**Wake County Public School System
RAND ROAD ELEMENTARY SCHOOL
FIRE ALARM REPLACEMENT**

ADDENDUM NO. 2

DATE: October 26, 2022

FA201
SHEET NO.

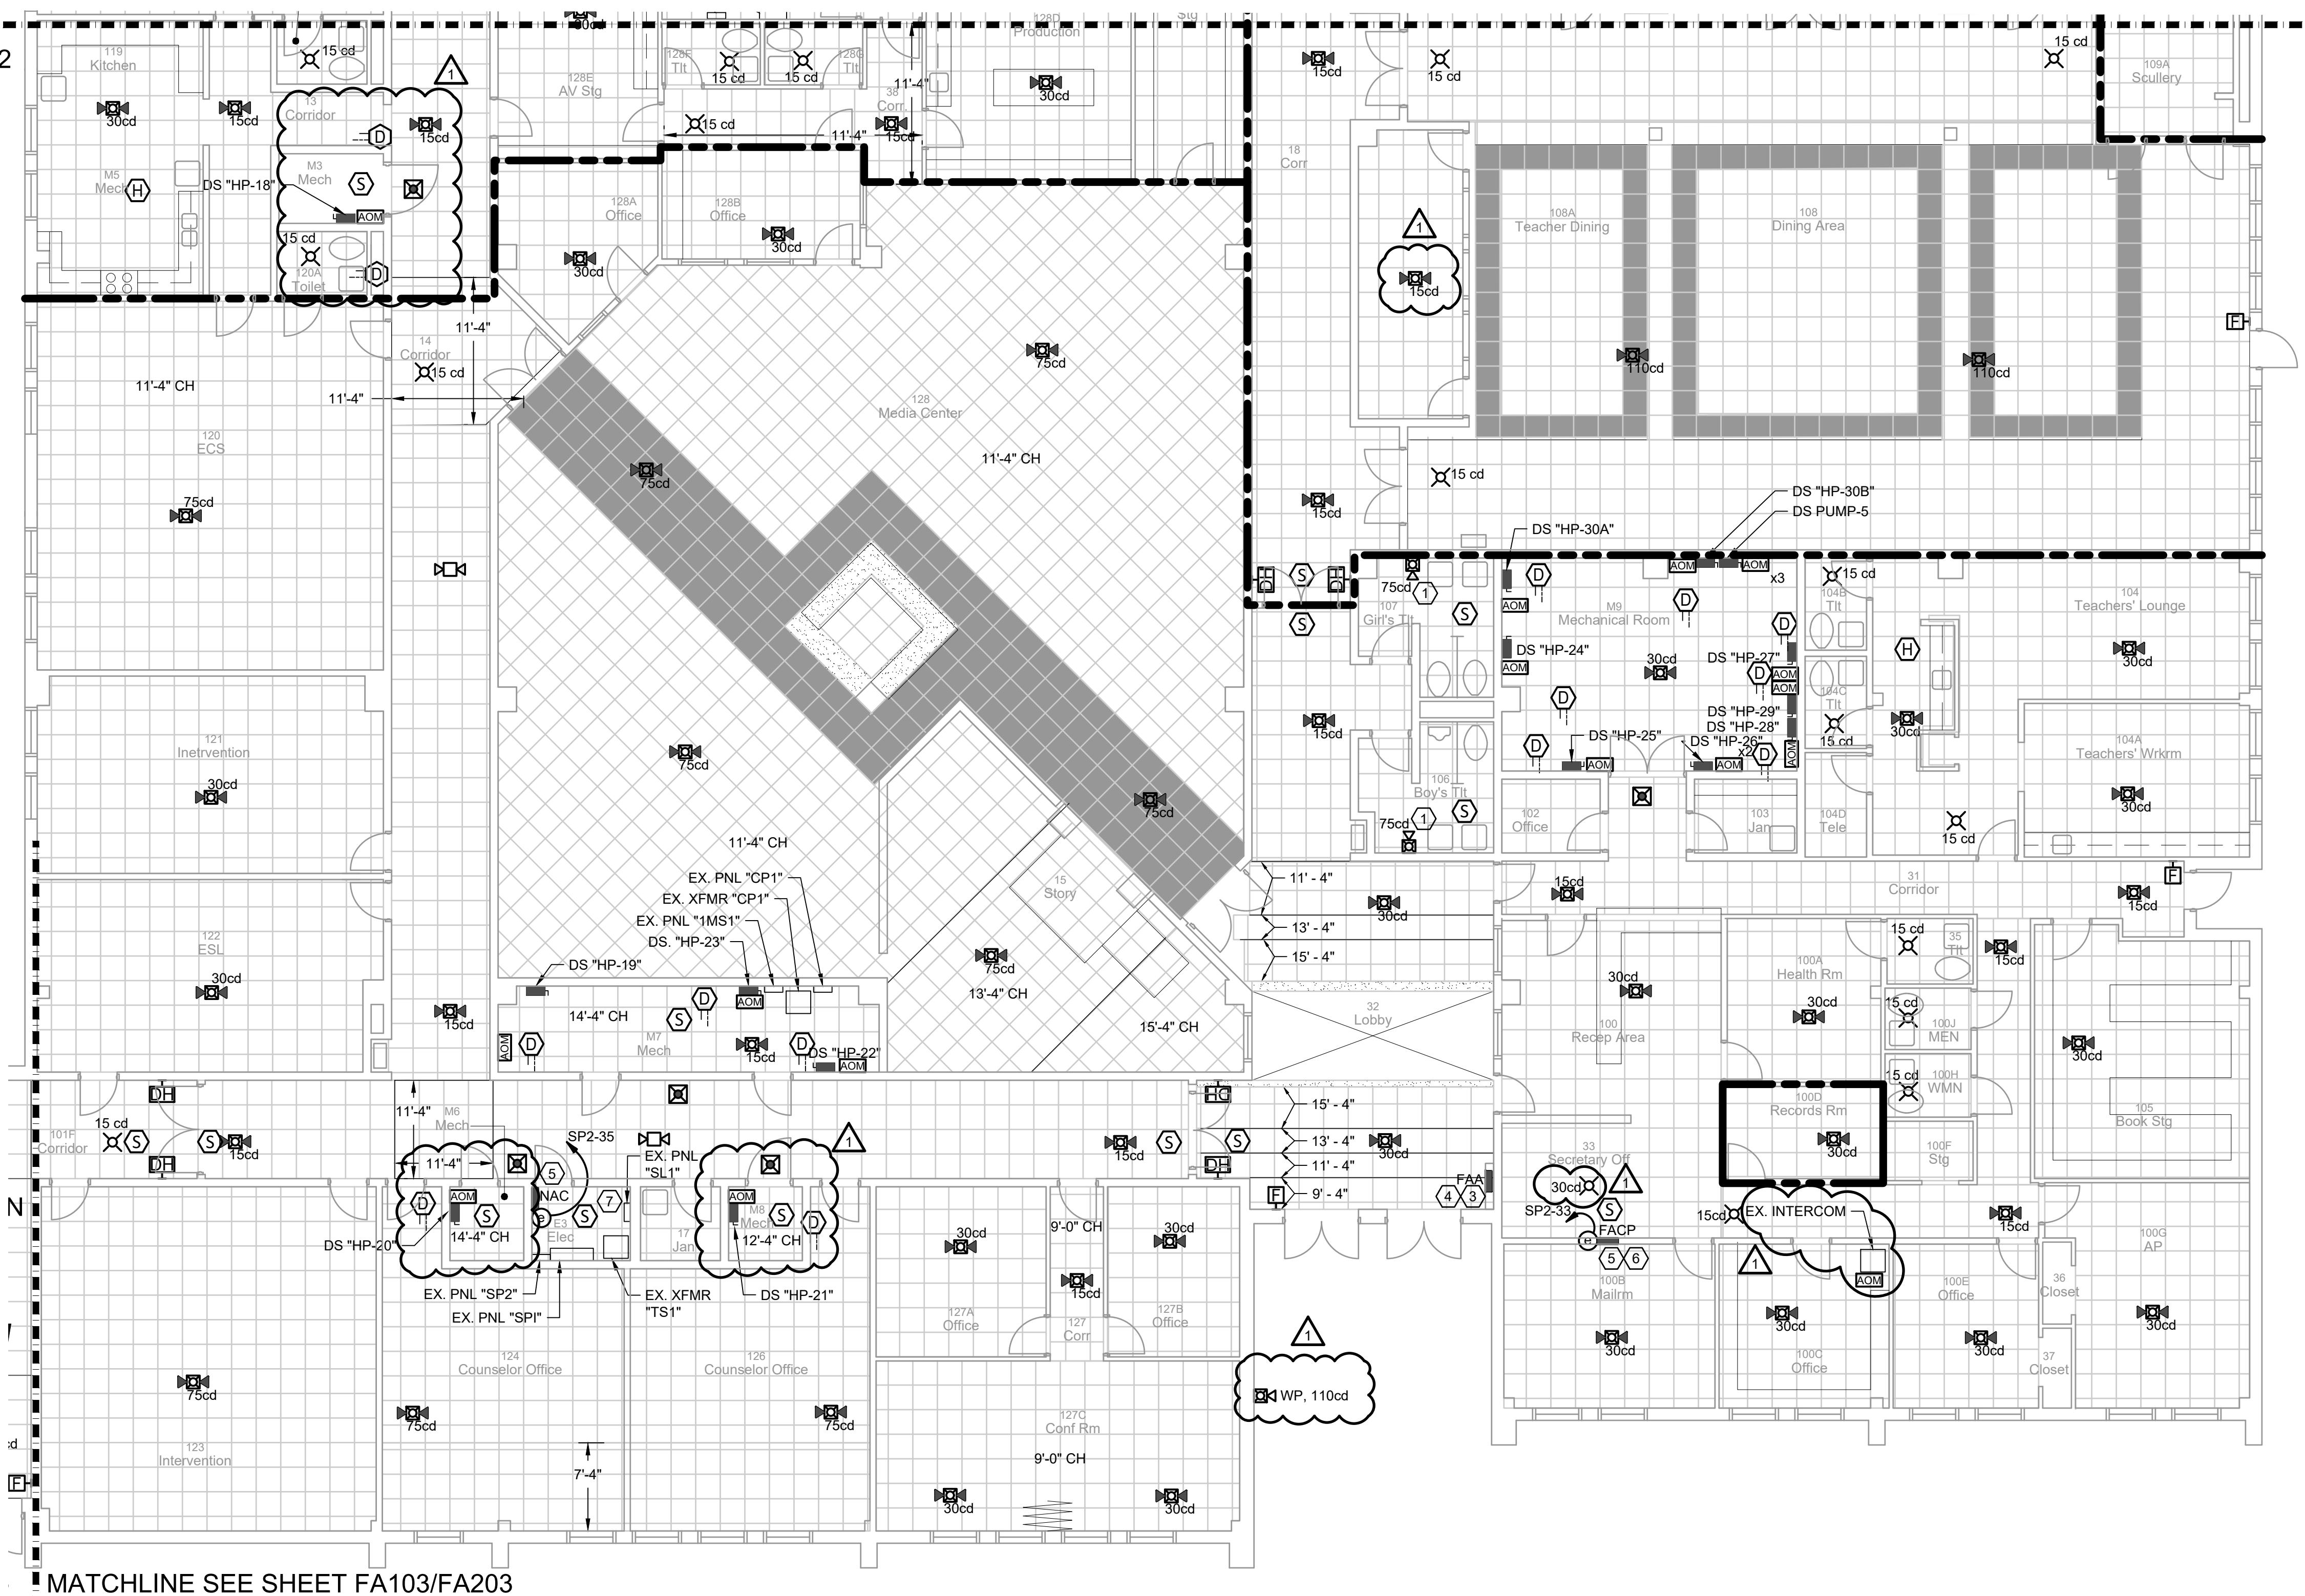
1. Sheets FA201, FA202, FA203, & FA204 were revised to remove full smoke detector coverage in the core area of the building. Note that, full coverage is still required in the classroom wings. Additional exterior notification devices were added. The intercom system shut-down relay was added to the plans.

FULL SMOKE DETECTOR COVERAGE
REMOVED REPLACED WITH DUCT DETECTORS

FA202

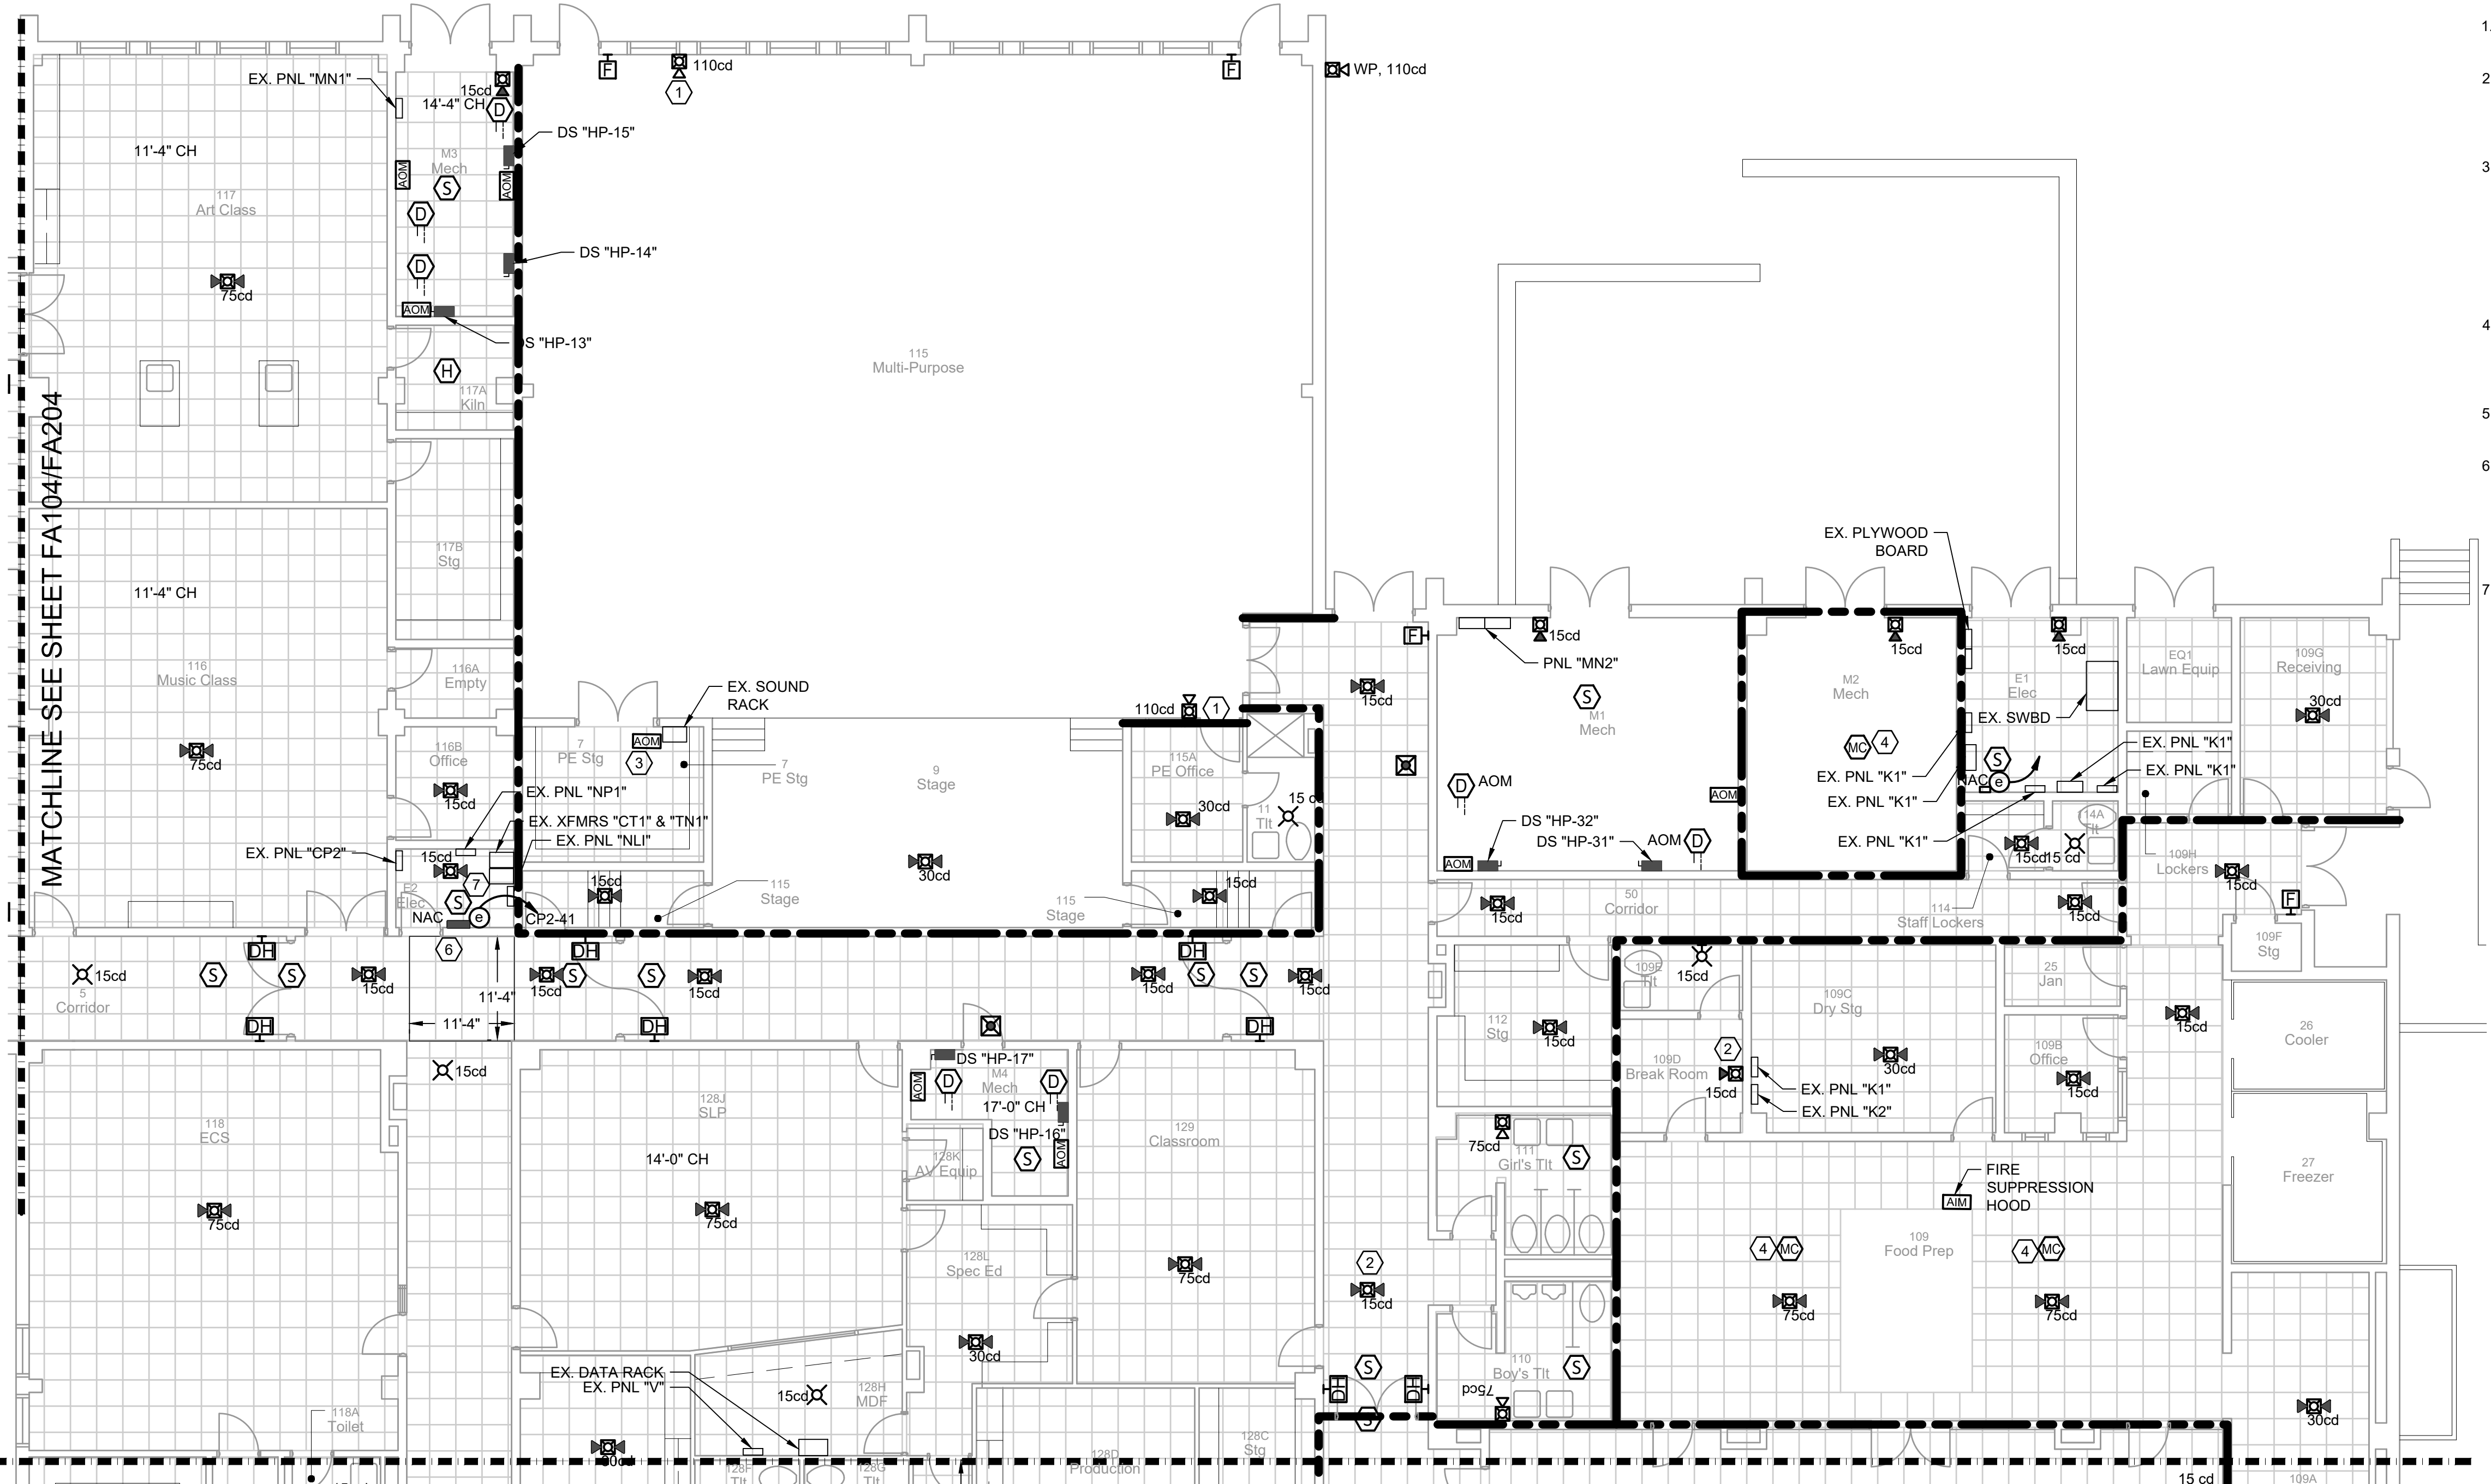
FULL SMOKE DETECTOR COVERAGE
 REMOVED REPLACED WITH DUCT DETECTORS
